At the meeting held in your office on April 3, 1987, it was agreed that Amphenol Corporation would review the groundwater contour maps for the former Amphenol facility in Broadview, Illinois. Attached for your review and information are copies of the revised maps as prepared by our consultant IT Corporation.

Project No. 303030

Transmittal
Revised Ground Water Contour Maps
Former Allied Corporation Facility
Broadview, Illinois

FIGURE 4

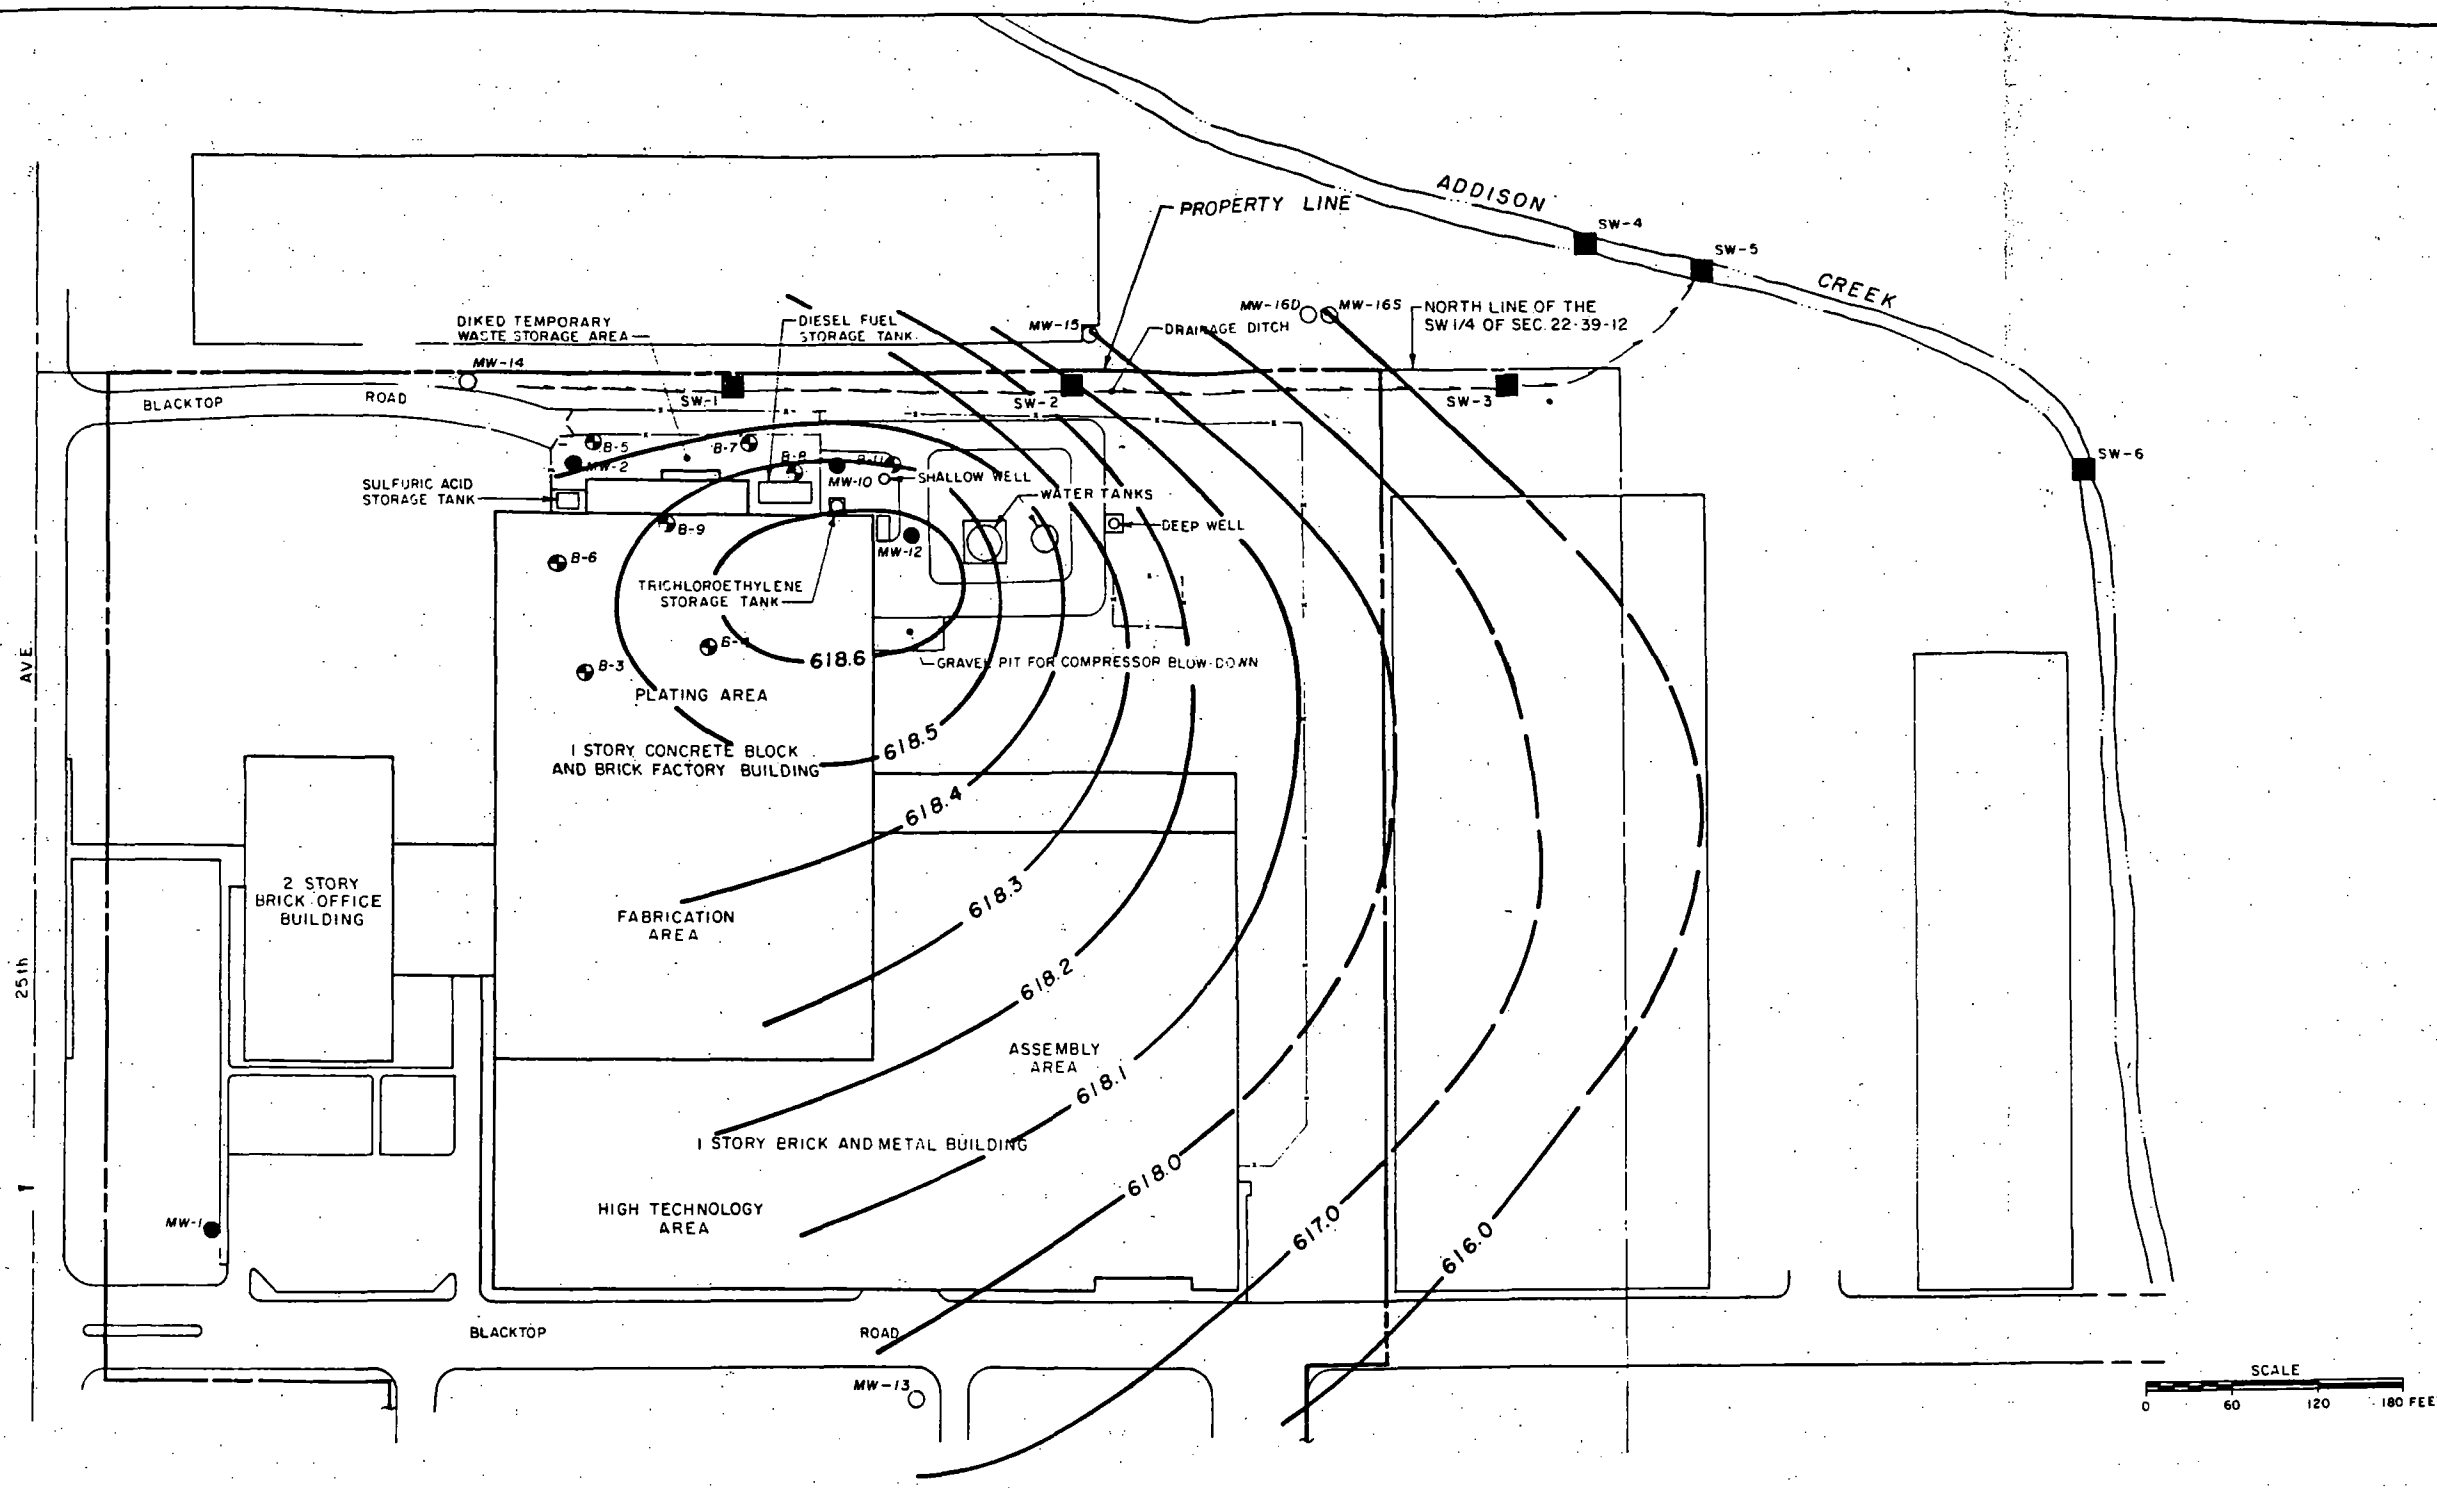
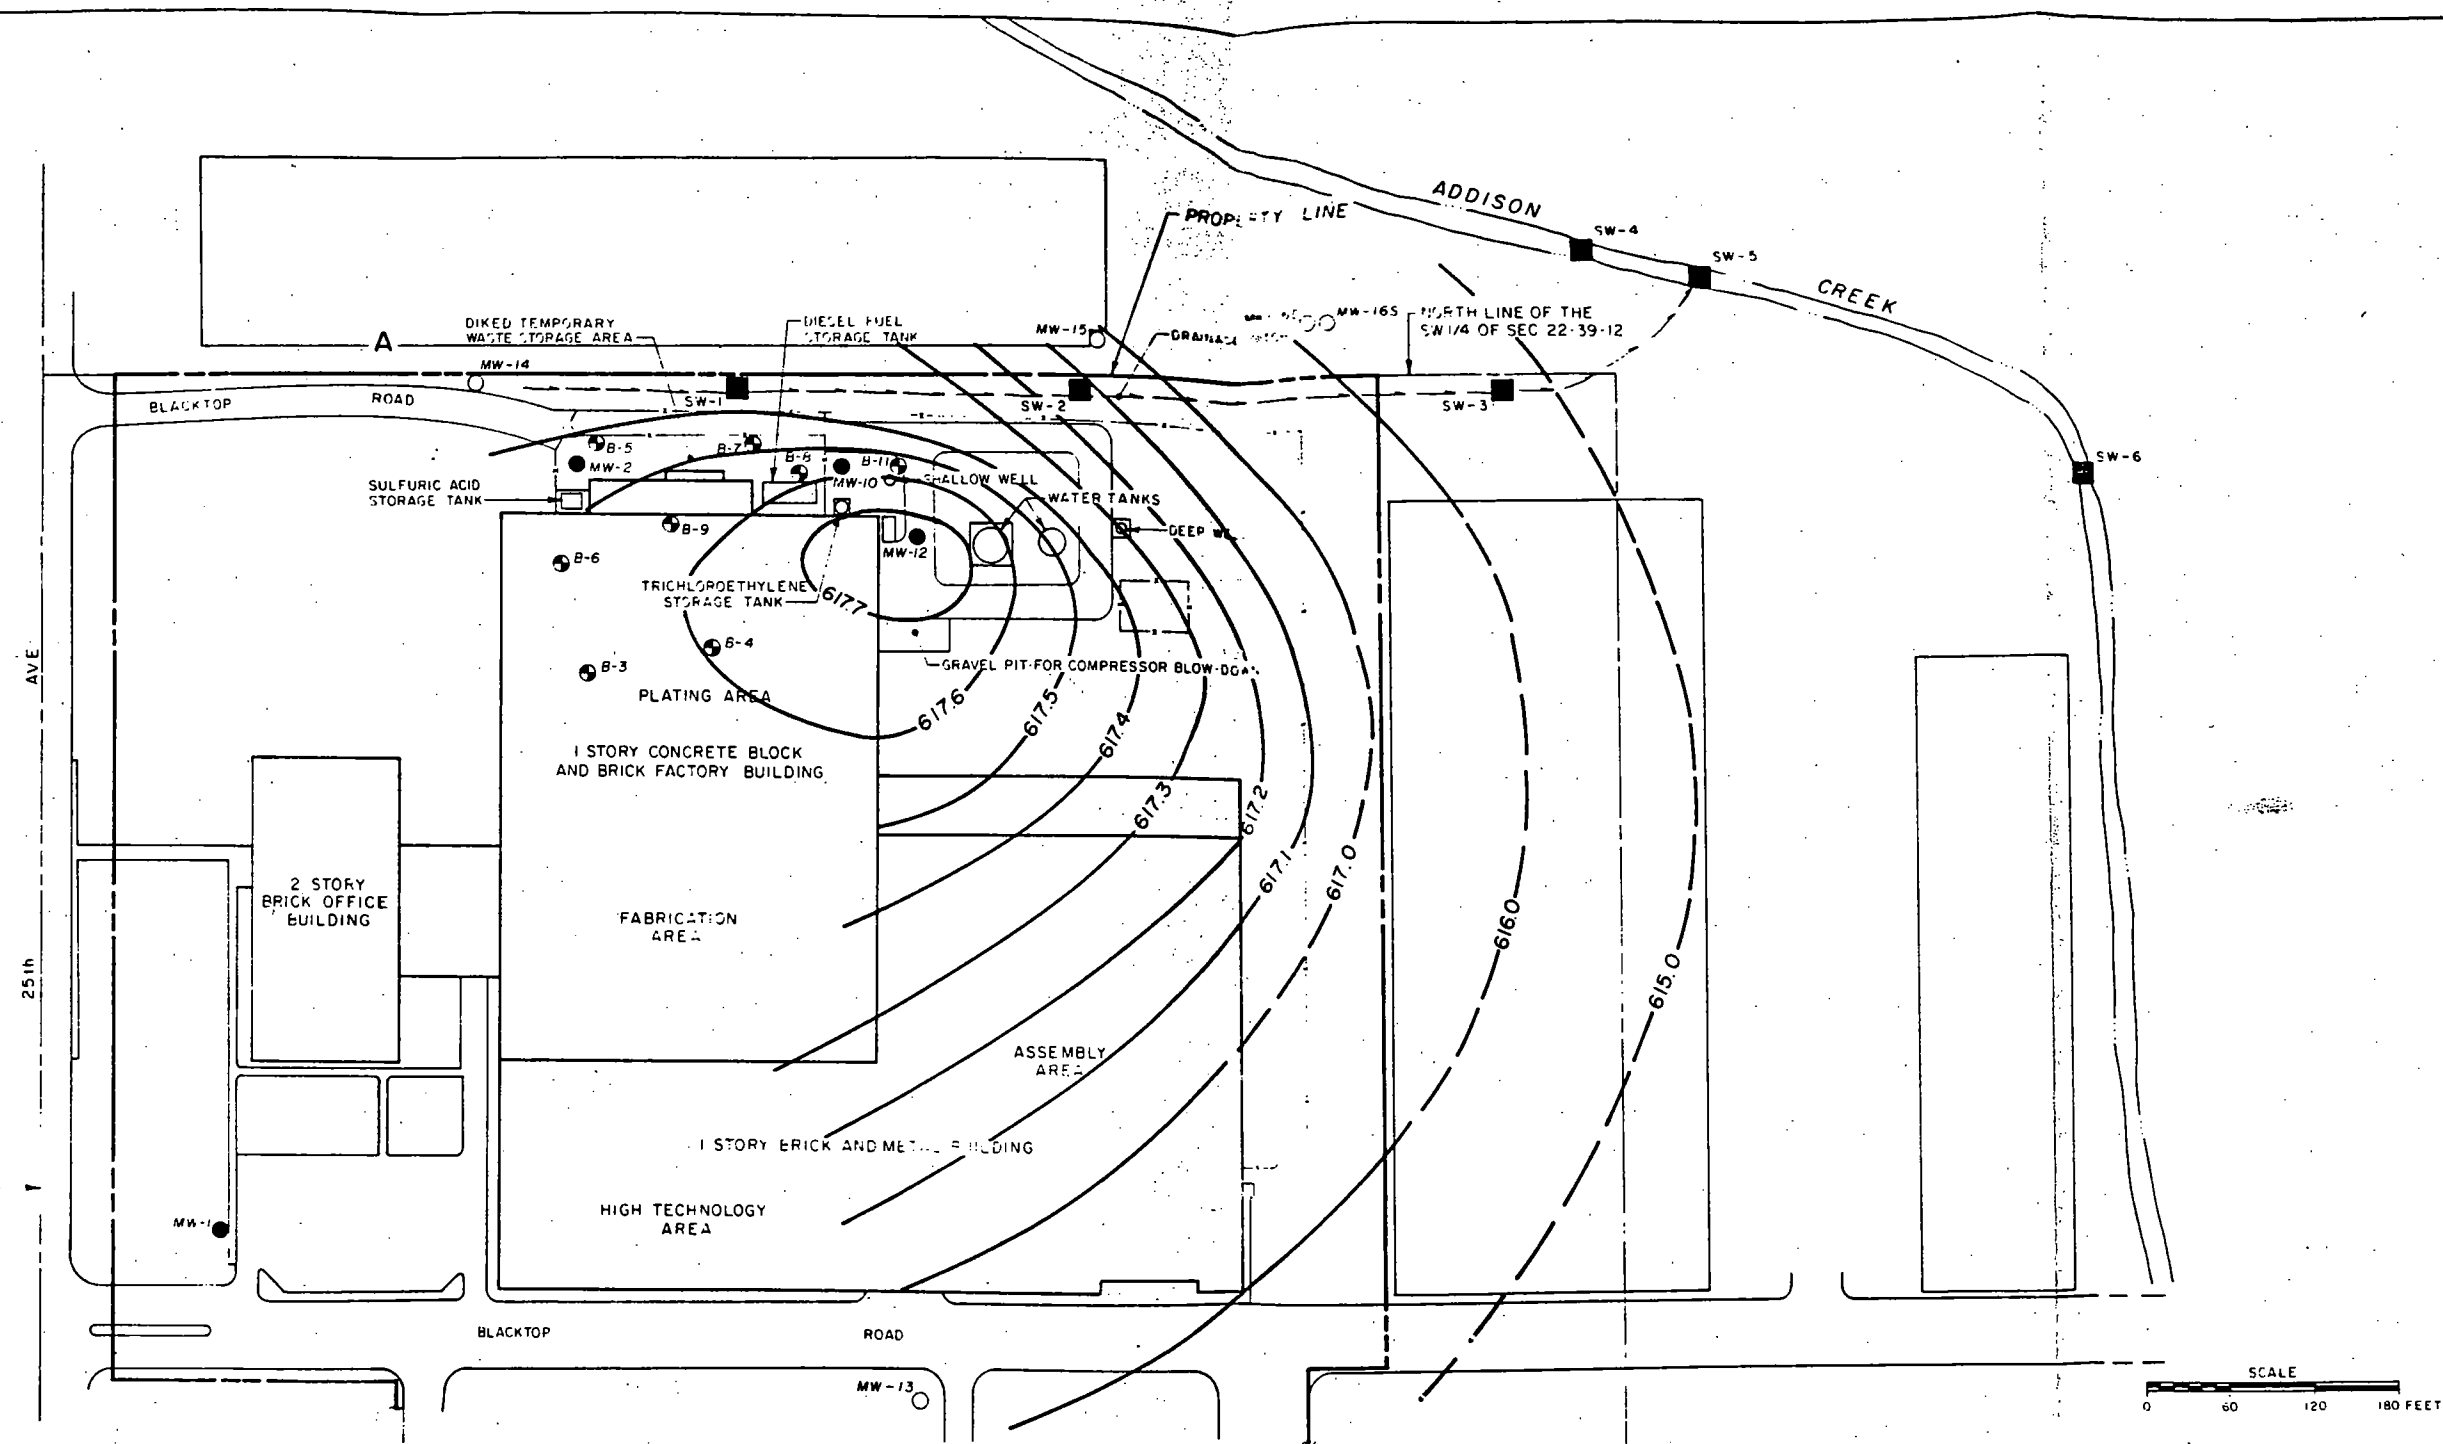
The maps prepared from the data obtained during the quarterly monitoring program (Figure 2 through 5) do not have the benefit of having data available from MW-14 and are thus limited to an interpretation of ground water flow which places more emphasis on the "mound" at MW-12 and its gradient toward MW-15 and MW-16S. This is what we believe to be the most correct interpretation of the direction of ground water flow based on the available data. In hindsight, Figures 2 through 5 would have benefited from having a ground water elevation measurement available from well No. MW-14. In all five figures, however, questions still remain in the interpretation of ground water flow from the north and its impact on flow in the vicinity of wells Nos. MW-15 and MW-16S. However, as we previously discussed, to answer these types of questions becomes more of a regional issue and would involve installation of more offsite wells. Figure 1, which benefits from the largest number of monitoring wells, gives strong indications of a flow component from the north, which along with the influence of the drainage ditch, indicates flow from the north-northwest is influencing well No. MW-16S more than flow from the plant area to the southwest.
